ADDENDUM NUMBER 1

- 1.01 DATE: April 7, 2015
- 1.02 PROJECT: Interior Renovations to the Mimosa - G Residence
Ramapo College of New Jersey
- 1.03 SNS PROJECT NUMBER: 4698G

INTERIOR RENOVATIONS
AT THE
MIMOSA - G RESIDENCE

ENLARGED FIRST FLOOR SANITARY PLAN
SCALE: 1/4"=1'-0"

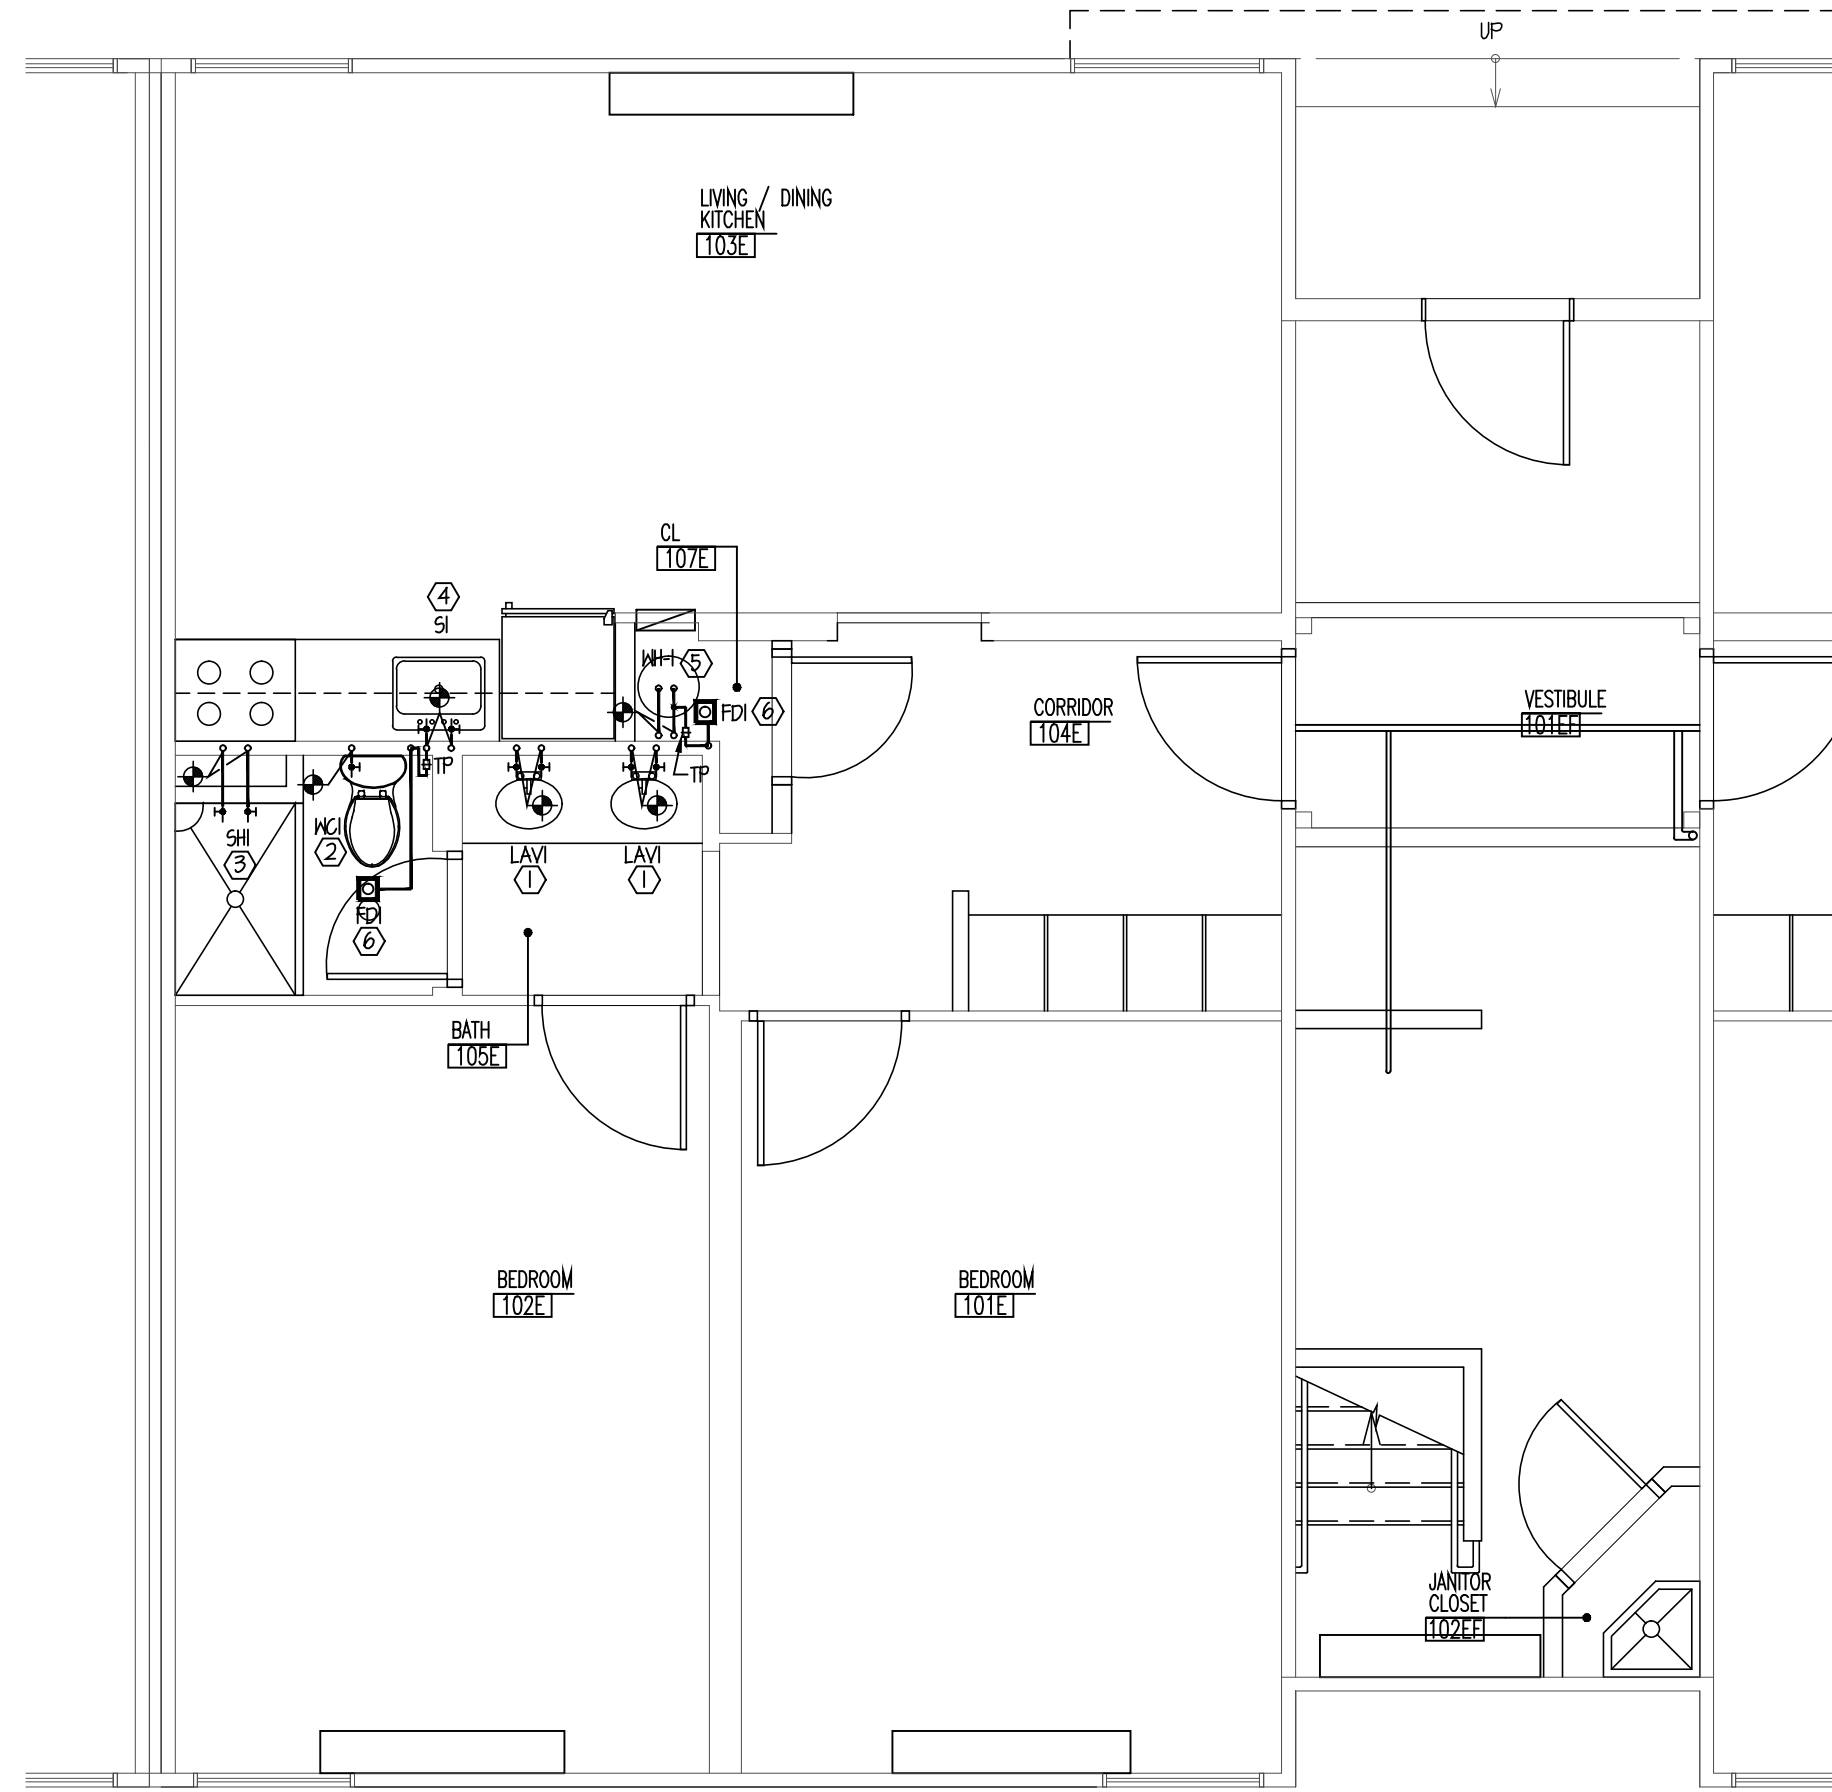
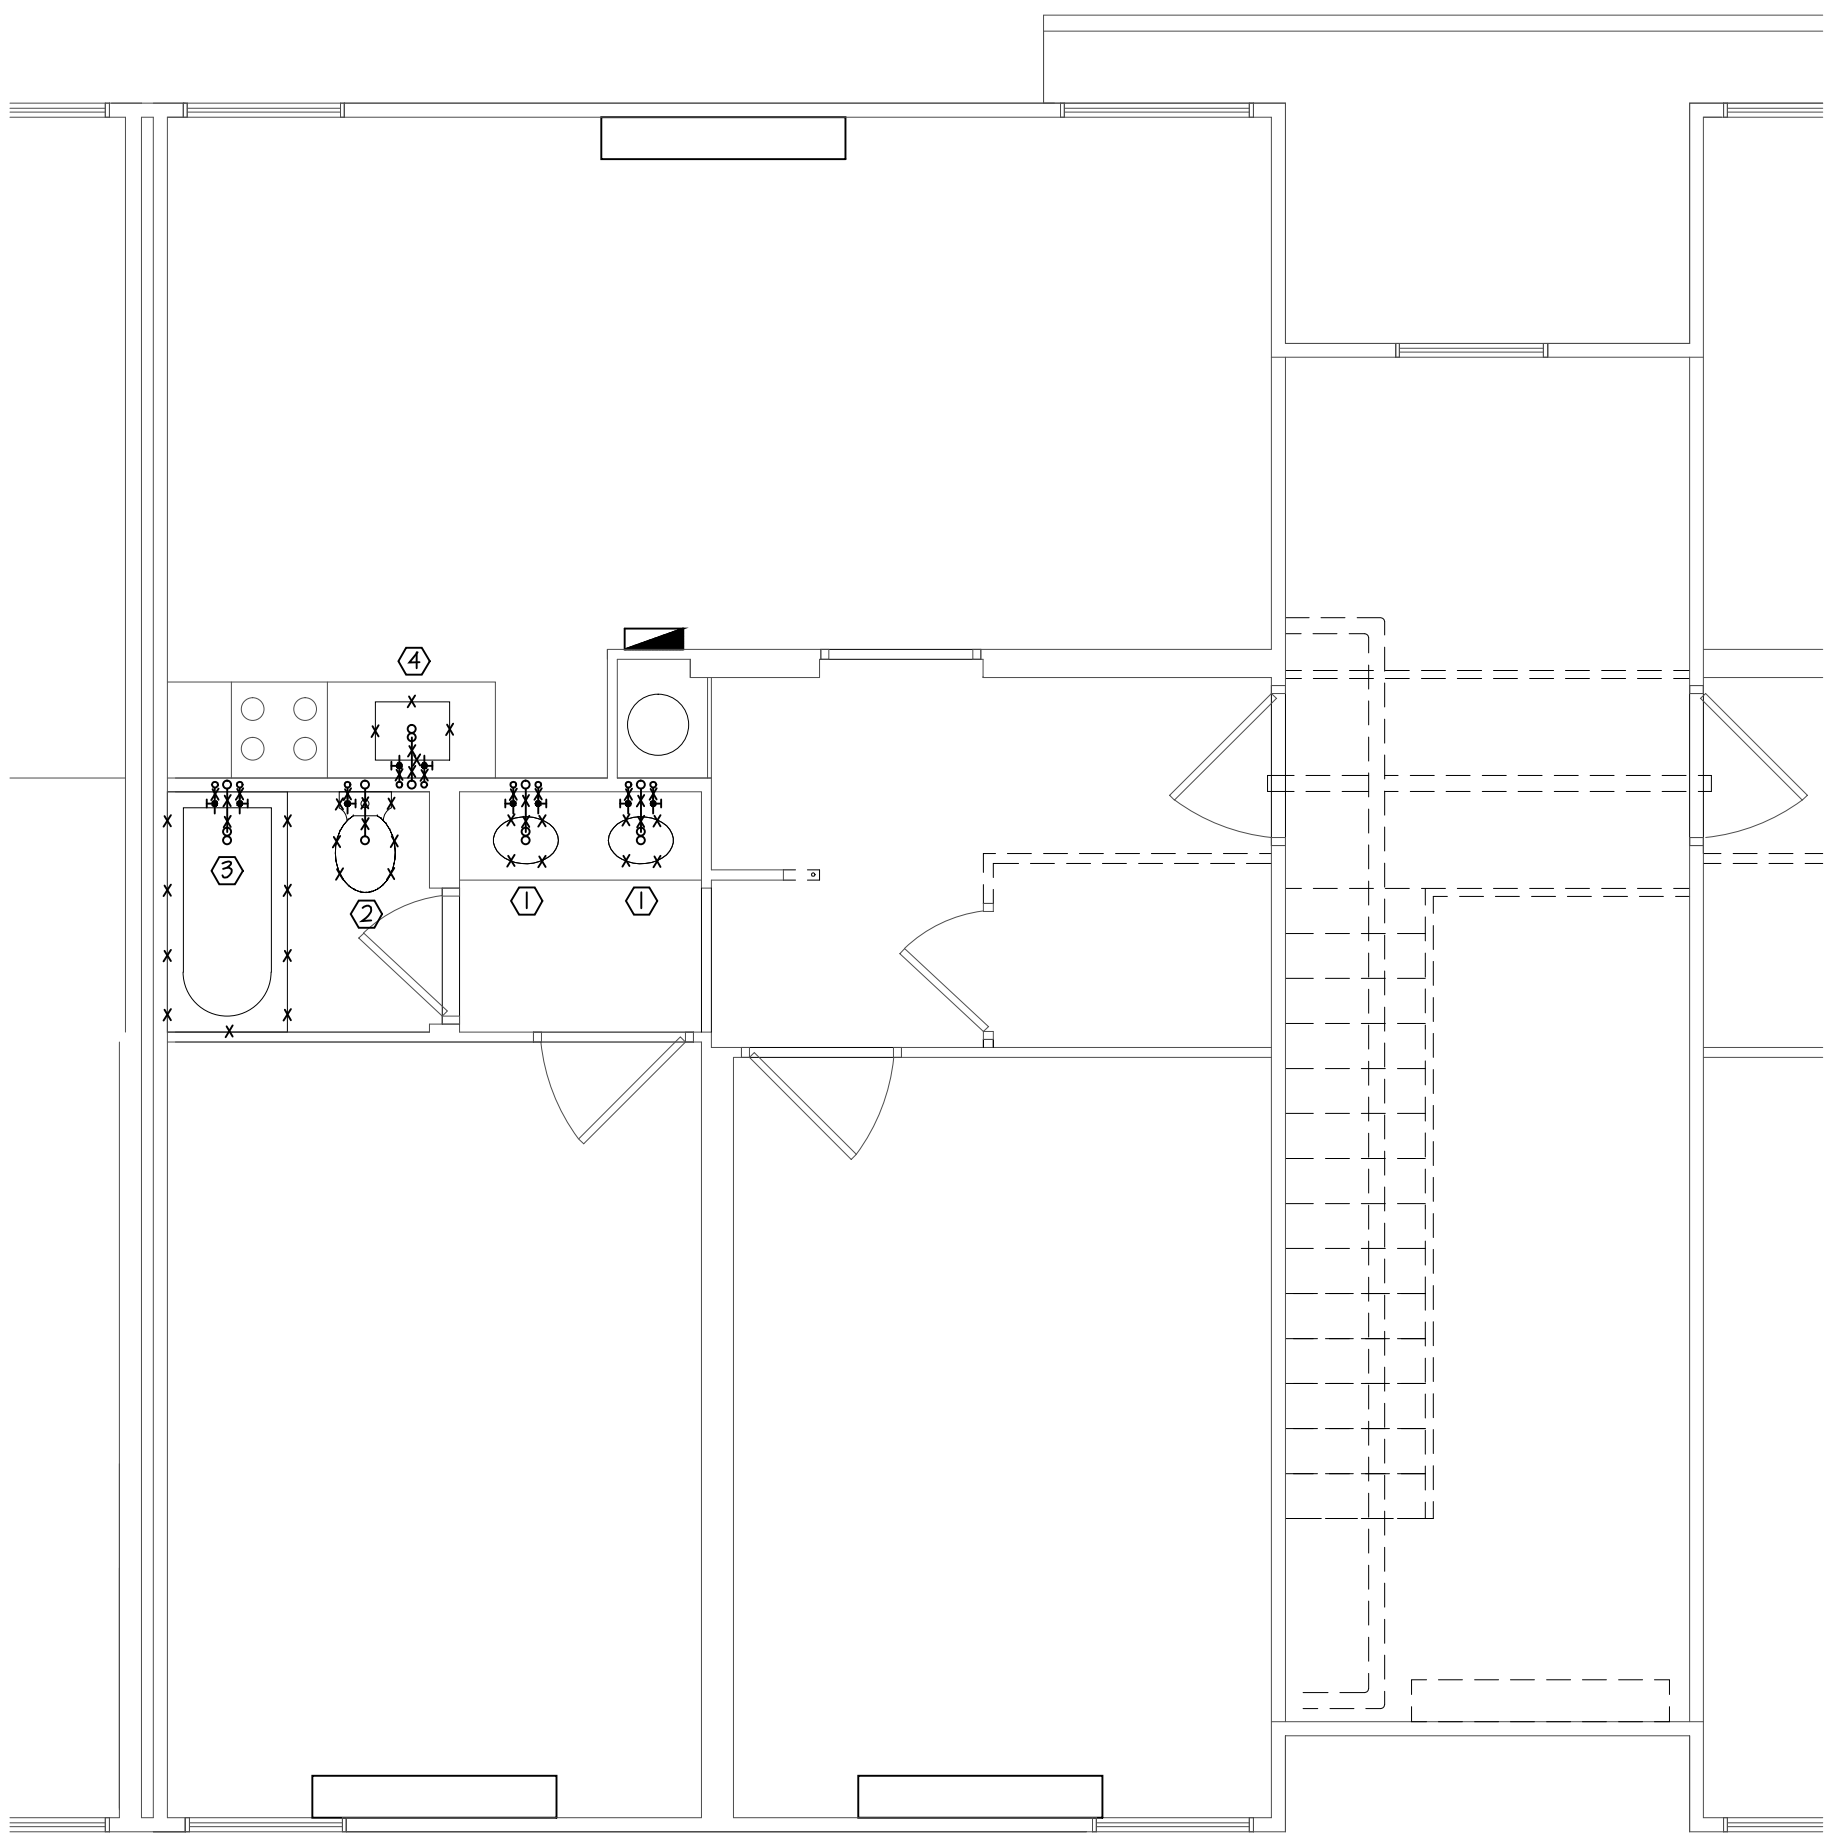
- 7.1. Added note indicating that all demolition work is by others under separate contract and filed under separate DCA permit application.
